From: John Petty [John.Petty@meritenergy.com]
Sent: Monday, December 20, 2004 2:15 PM
To: Catanach, David
Cc: Beverly Hatfield; John Petty; David Hertel
Subject: Re: Fren/Turner Wells

From: Catanach, David
Sent: Monday, December 13, 2004 10:20 AM
To: 'john.petty@meritenergy.com'
Subject: Fren/Turner Wells

Pressure Increase

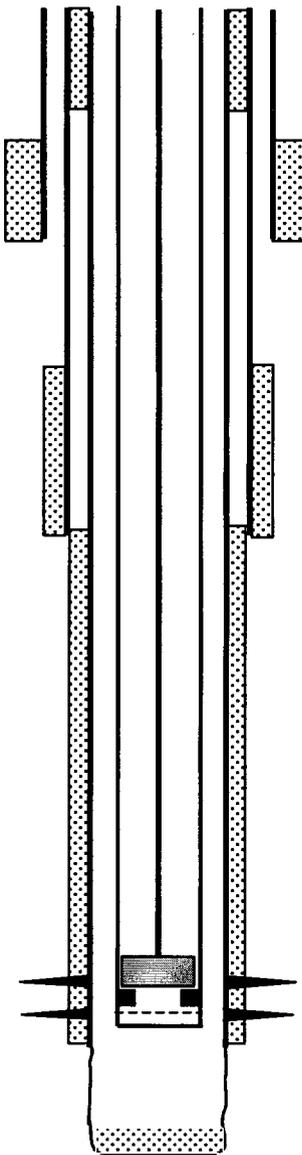
I got your phone message. I looked at the step rate tests and they look okay. I also reviewed the sundry notices for the well repairs required by WFX-795 and 796. It seems to me that some of the sundry notices don't give all the information on the well repair. For example, the Turner B No. 50 does not give any cementing information. Same for the Turner A No. 36. Also, what did you find on the Fren Oil Company No. 3? Also, was no work done on the Cedar Lake No. 3Y?

I received your data and I am currently reviewing it. With regards to the Turner "B" No. 44, your sundry shows no work done on this well. The application for WFX-795 shows that this well had a cement top of 2535 by temperature survey. Also, your sundry notices for the Fren Oil Company Nos. 3 and 13 show no work done. Can you further elaborate on these wells?

Fren Oil Company #3 - A CBL was run on 3/15/04. The log showed that the top of cement behind the 5-1/2" casing was 1800'. This is into the next casing shoe - 7" casing is at 1802' (see attached schematic).

Fren Oil Company No. 3 - No remedial cementing work was done on this well because it was not necessary. The CBL field personnel ran on 3/15/04 showed good cement at 1800'. The 7" casing shoe is at 1802'. The interval we were supposed to protect was 1850'-2030'. This zone is already behind good pipe (as known by pipe tallies and pressure tests) and good cement (as shown by 3/15/04 CBL). This indicates the zone of interest is covered with cement.
